D350-748-103
Job Sheet 191000

Part Name: AS350 / AS355 Stainless Steel Fwd Crosstube

DRAWING NO. D350-748-143	TITLE CROSSTUBE	REV. A	DART AEROSPACE LTD ENGINEERING ORDER		D.E.O. NO. D350-748-143-A-1	SHEET NO. SHEET 1 OF 1	SCALE NTS
DRAWN <i>Q</i>	CHECKED <i>ASS</i>	MFG. APPR. <i>[Signature]</i>	APPROVED <i>[Signature]</i>		DE APPR. <i>[Signature]</i>		
DATE 15.11.18	DATE 15.11.18	DATE 16.02.19	DATE FEB 19 2016		DATE 2016.02.19

**D350-748-143
ASSEMBLY DETAIL**

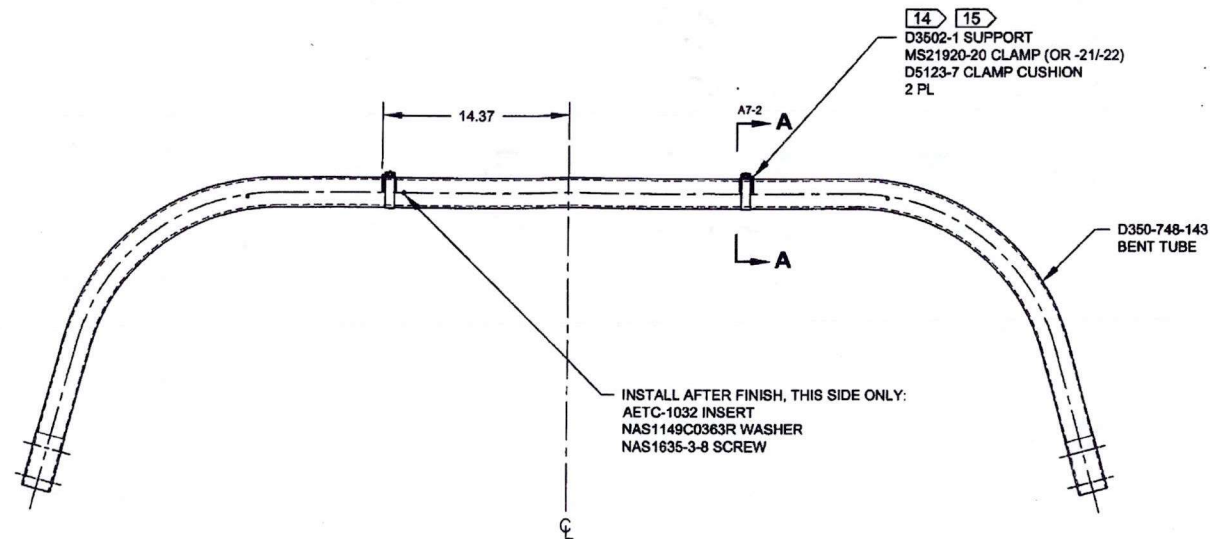
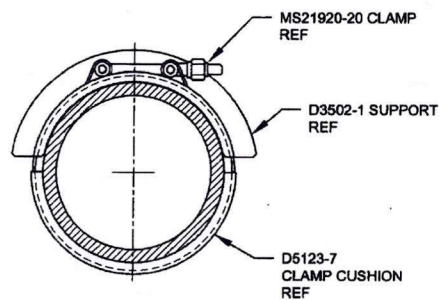
AMEND NOTE 2 (SHEET 1) AS FOLLOWS:

- 2) FINISH: PREPARE SURFACE PER DART QSI 005 4.1.4
 PRIME INSIDE AND OUTSIDE PER DART QSI 005 4.2
 PAINT OUTSIDE PER DART QSI 005 4.2
 OR
 POWDER COAT WHITE (4.3.5.2) PER DART QSI 005 4.3
